Access Compliance Report Public Rights-of-Way (Curb Ramps)

Main Street: SMOKE_TREE_DR		Cross Street: SCARLET_MAPLE_DR		Location:	SE
ADA ID: RPAT211102153732	Ramp Type: Type 4 - Parallel	Initial Pass/Fail: Fail	Overall Compliance: No	Severity Score:	32
Codes/Mitigation Info/Possible Solution			Field Measurements/Component Compliance

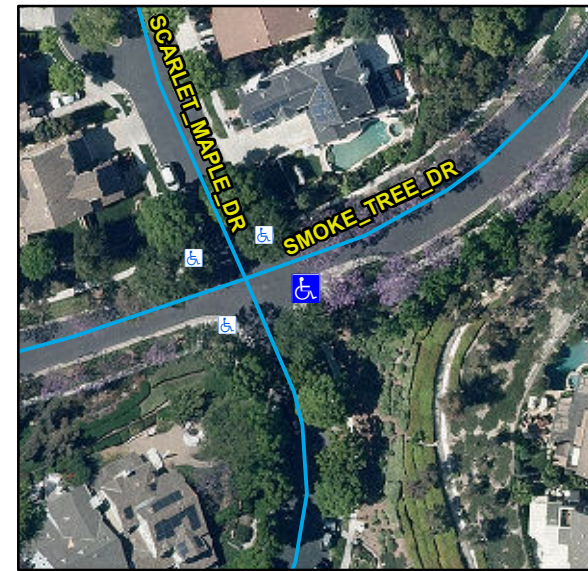
R204.3, R304.3.2, R304.5.3, STD 1115

Remove & Replace Curb Ramp With Two New Directional Ramps or Equivalent.
